Access Compliance Report

Public Rights-of-Way

(Curb Ramps)

Intersection ID: 48950	Main Street: DAVID_JENNINGS_AV	Cross Street: BONROI_AV	Location: NW
ADA ID: FFFD4DA6C5AF	Ramp Type: BlendTrans1	Initial Pass/Fail: Pass	Overall Compliance: No
Severity Score: 0			
Codes/Mitigation Info/Possible Solution		Field Measurements/Component Compliance

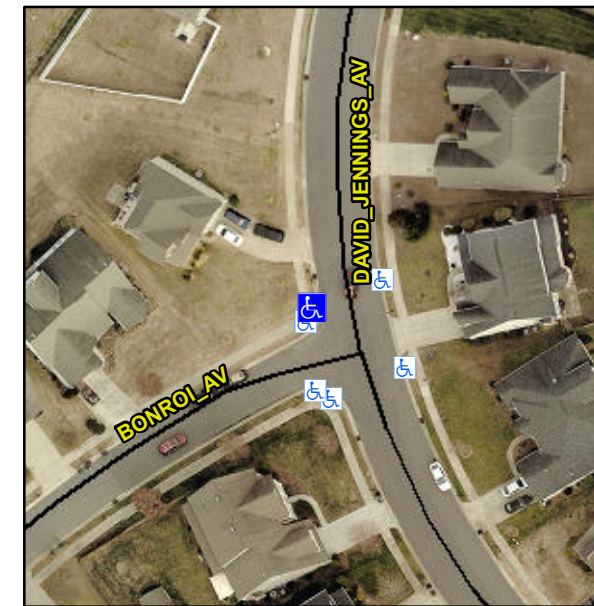
N/A	Ramp inside XWalk1?	N/A	N/A	Ramp inside XWalk2?	N/A
	Road Slope (%)	3.8		Clear Space?	Yes
	Road X Slope (%)	2.8	N/A	Clear Space to XWalk (in)	N/A
Yes	Any Obstructions?	No	Yes	Storm Grate/Utility Hazard?	No
	Obstruction Type			Storm Grate/Utility Type	
		N/A			N/A
			Yes	Surface Condition? (G/P)	Good
			No	Curb Slope (%)	16.3

Remove & Replace Curb Slope and Extend Ramp.
